**ADDENDUM NO. 2  
PLAYGROUND DESIGN, SUPPLY, AND INSTALLATION – TRANBY PARK  
RFP NO. 54-20**

**March 17, 2020**

Please see attached items 4, 5, 6 for Appendix G.

**PLAYGROUND PIT DETAILS**  
 'A'

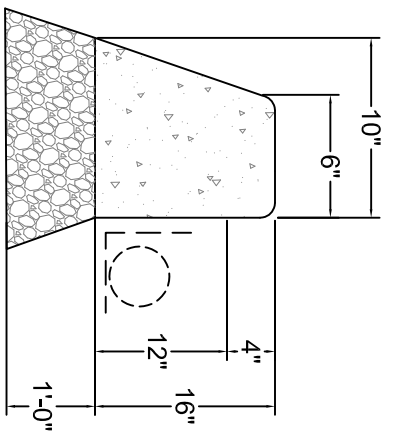
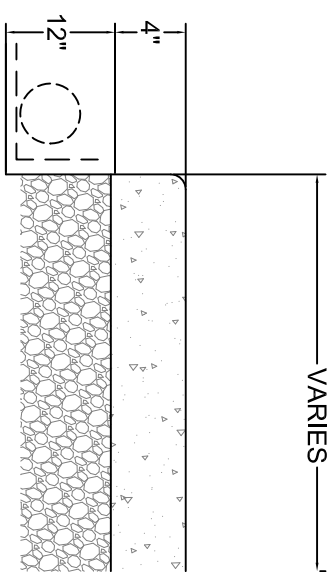
AFTER PLAY EQUIPMENT IS INSTALLED BACKFILL WITH ADDITIONAL GRANULAR 'A' AND COMPACT AS REQUIRED. GRANULAR 'A' TO BE NO MORE THAN 100mm (4") BELOW TOP OF CURB OR SIDEWALK PERIMETER (BY C.O.W.)

**NOTE:**  
 THE CITY OF WINDSOR (C.O.W.) WILL BE RESPONSIBLE FOR THE INSTALLATION OF ALL PLAYGROUND PITS AS PER THIS DETAIL. THE PROPONENT WILL BE RESPONSIBLE TO SUPPLY AND INSTALL ADDITIONAL GRANULAR 'A' AND TO COMPACT THE BASE PRIOR TO SURFACING BEING INSTALLED. ALL PLAYGROUND EQUIPMENT AND RUBBER SURFACING SHALL BE SUPPLIED AND INSTALLED AS PART OF THIS RFP.

**PLAYGROUND PIT DETAILS**  
**'B'**

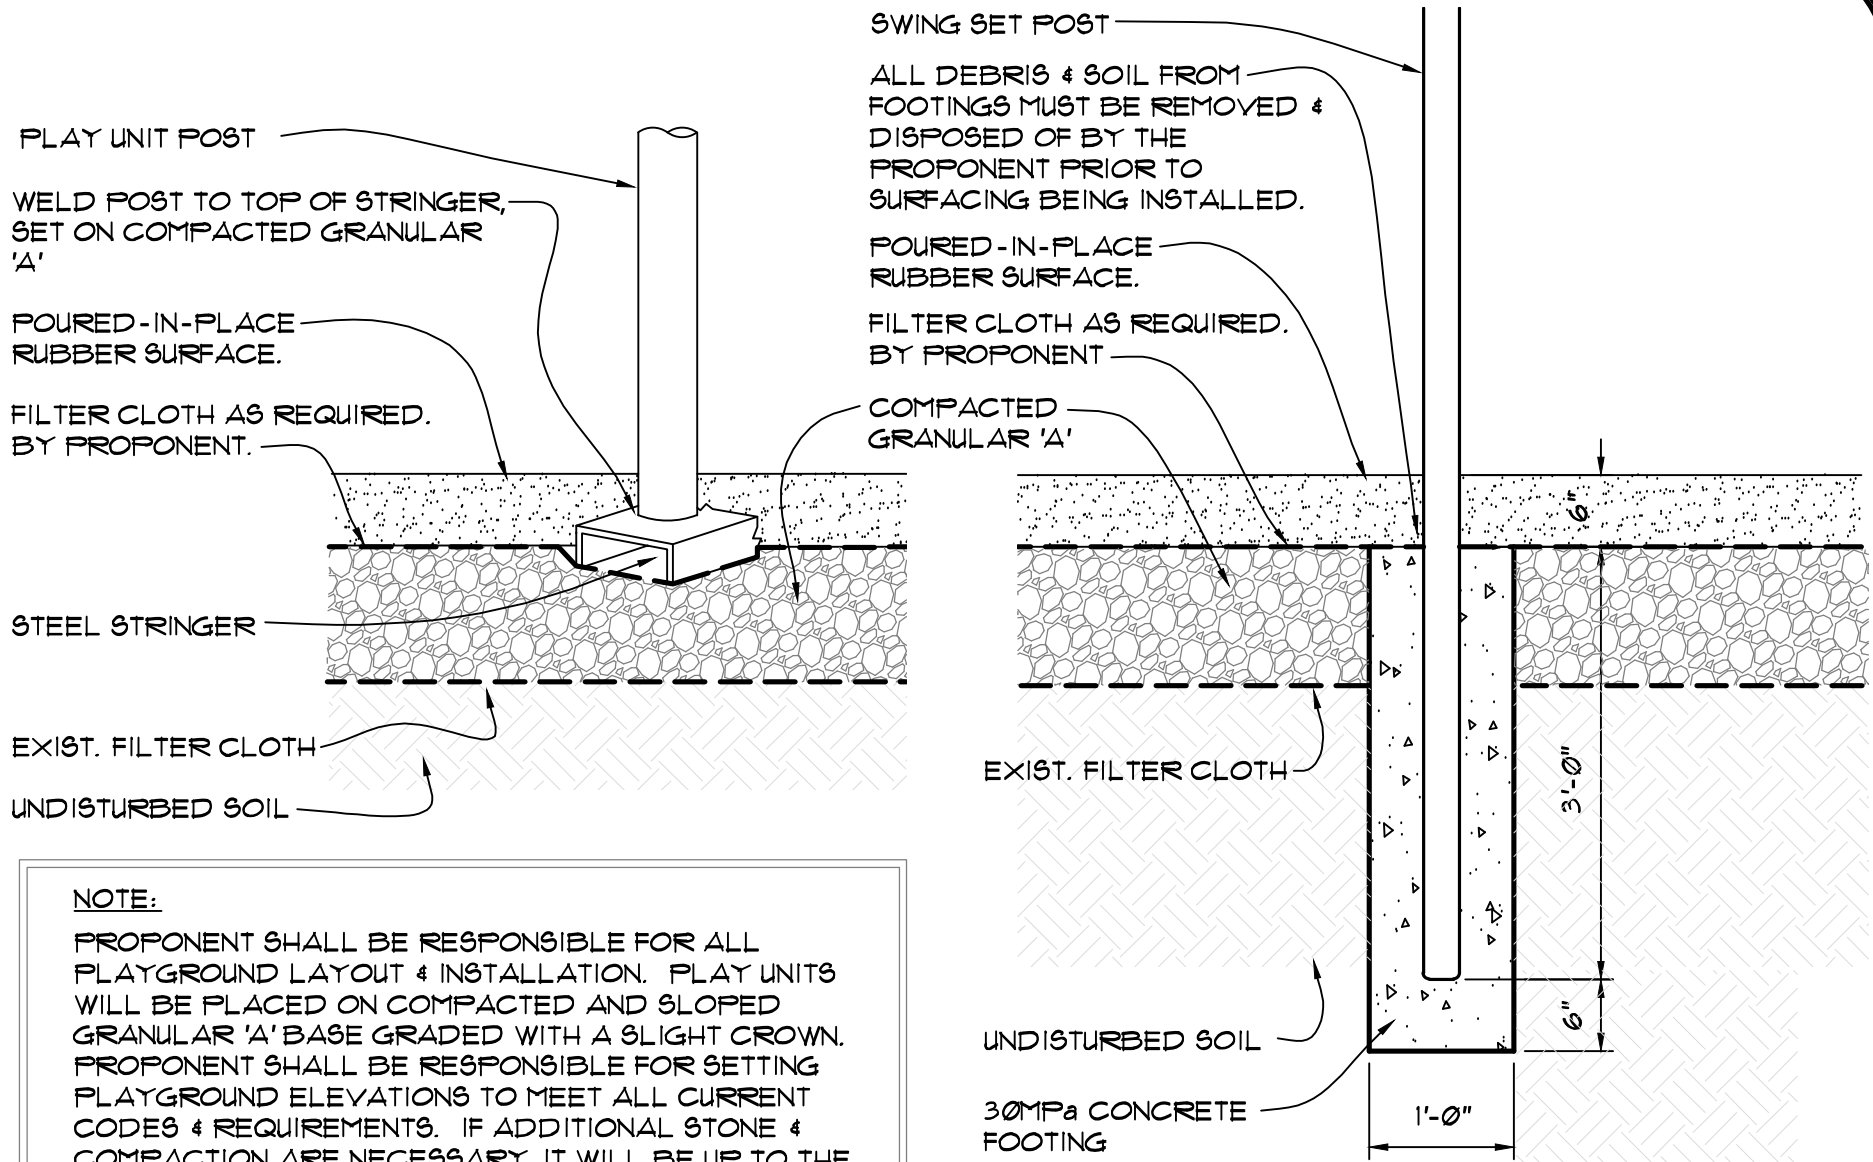
**NOTE:**  
 PROPONENT SHALL BE RESPONSIBLE FOR ALL PLAYGROUND LAYOUT & INSTALLATION. PLAY UNITS WILL BE PLACED ON COMPACTED AND SLOPED GRANULAR 'A' BASE GRADED WITH A SLIGHT CROWN. PROPONENT SHALL BE RESPONSIBLE FOR SETTING PLAYGROUND ELEVATIONS TO MEET ALL CURRENT CODES & REQUIREMENTS. IF ADDITIONAL STONE & COMPACTION ARE NECESSARY, IT WILL BE UP TO THE PROPONENT TO INCLUDE THIS THE THEIR PROPOSAL.
